United States Patent and Trademark Office

APPLICATION NO.	FI	LING DATE	FIRST NAMED INVENTOR	ATTORNEY DOCKET NO.	CONFIRMATION NO.				
09/966,427	(09/28/2001	Harini V. Sundaresan	TI-31767	6354				
23494	7590	07/06/2005		EXAM	INER				
TEXAS IN P O BOX 65		ENTS INCORPOR	TORRES,	TORRES, JUAN A					
DALLAS, 7				ART UNIT	PAPER NUMBER				
,			2631

DETAILED ACTION

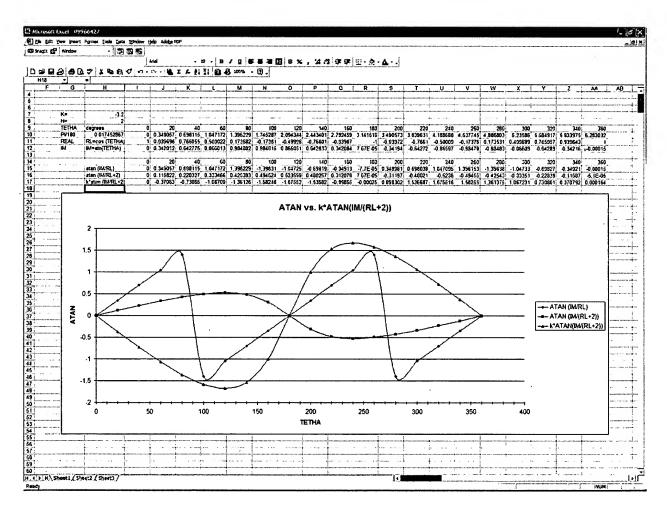
Also if the value of k is chose equal to –3.2 the comparison still is not persuasive, because the results are even worse:

K= N=	-3.2 2															
TETHA	degrees	0	20	40	60	80	100	120	140	160	180	200	220	240	260	280
PI/180	0.017452867	0	0.349057	0.698115	1.047172	1.396229	1.745287	2.094344	2.443401	2.792459	3.141516	3.490573	3.839631	4.188688	4.537745	4.886803
REAL	RL=cos (TETHA)	- 1	0.939698	0.766055	0.500022	0.173682	-0.17361	-0.49996	-0.76601	-0.93967	-1	-0.93972	-0.7661	-0.50009	-0.17376	0.173531
IM	IM=sin(TETHA)	0	0.342012	0.642775	0.866013	0.984802	0.984815	0.886051	0.642833	0.342084	7.67E-05	-0.34194	-0.64272	-0.86597	-0.98479	-0.98483
		0	20	40	60	80	100	120	140	160	180	200	220	240	260	280
	atan (IM/RL)	0	0.349057	0.698115	1.047172	1.396229	-1.39831	-1.04725	-0.69819	-0.34913	-7.7E-05	0.348981	0.698038	1.047095	1.396153	-1.39638
	atan (IM/RL+2)	0	0.115822	0.228327	0.333466	0.425393	0.494524	0.523599	0.480257	0.312078	7.67E-05	-0.31197	-0.48021	-0.5238	-0.49455	-0.42543
	k*atan (IM/RL+2)	0	-0.37063	-0.73065	-1.06709	-1.36126	-1.58248	-1.67552	-1.53882	-0.99865	-0.00025	0.998302	1.538687	1.675516	1.58255	1.361375

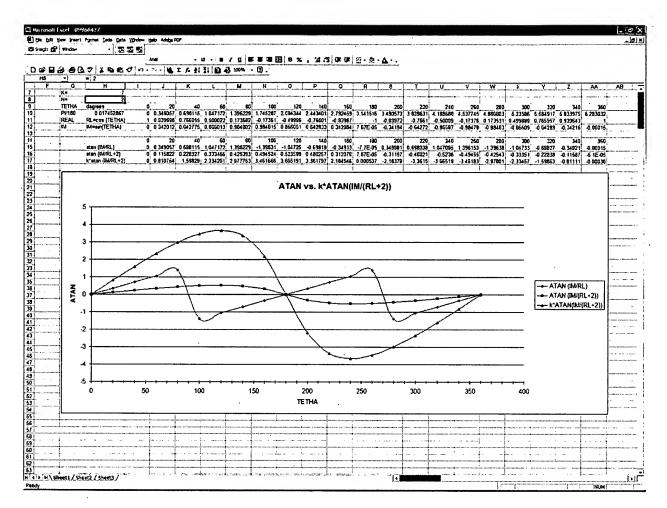
Claims 1-10 rejected under 35 U.S.C. 101 because the disclosed invention is inoperative and therefore lacks utility. The disclosure present a method for computing the value of arctangent (IM/RL) using the alternative formula 7*arctangent (IM/(RL+2)) (see original specification page 13 lines 3-8) in all the values of the imaginary part (IM=sin (θ)), and the real part (RL=cos (θ)). The following graphic is a representation of the two values of arctangent (IM/RL) and 7*arctangent (IM/(RL+2)) (in the OY axes) for θ = 0 to θ =360 is steps of 20 degrees:

K=	7															
N=	2															
TETHA	degrees	0	20	40	60	80	100	120	140	160	180	200	220	240	260	280
PI/180	0.017452867	0	0.349057	0.698115	1.047172	1.396229	1.745287	2.094344	2.443401	2.792459	3.141516	3.490573	3.839631	4.188688	4.537745	4.886803
REAL	RL=cos (TETHA)	1	0.939696	0.766055	0.500022	0.173682	-0.17361	-0.49996	-0.76601	-0.93967	-1	-0.93972	-0.7661	-0.50009	-0.17376	0.173531
IM	(M=sin(TETHA)	0	0.342012	0.842775	0.866013	0.984802	0.984815	0.866051	0.642833	0.342084	7.67E-05	-0.34194	-0.64272	-0.86597	-0.98479	-0.98483
		0	20	40	60	80	100	120	140	160	180	200	220	240	260	280
	atan (IM/RL)	0	0.349057	0.698115	1.047172	1.398229	-1.39631	-1.04725	-0.69819	-0.34913	-7.7E-05	0.348981	0.698038	1.047095	1.396153	-1.39638
	atan (IM/RL+2)	0	0.115822	0.228327	0.333466	0.425393	0.494524	0.523599	0.480257	0.312078	7.67E-05	-0.31197	-0.48021	-0.5238	-0.49455	-0.42543
	k*atan (IM/RL+2)	0	0.810754	1.59829	2.334261	2.977753	3.481666	3.665191	3.361797	2.184546	0.000537	-2.18379	-3.3615	-3.66519	-3.46183	-2.97801

It is evident that the approach is not good at all. The proposed claims lack of utility in the full range of the disclosure.
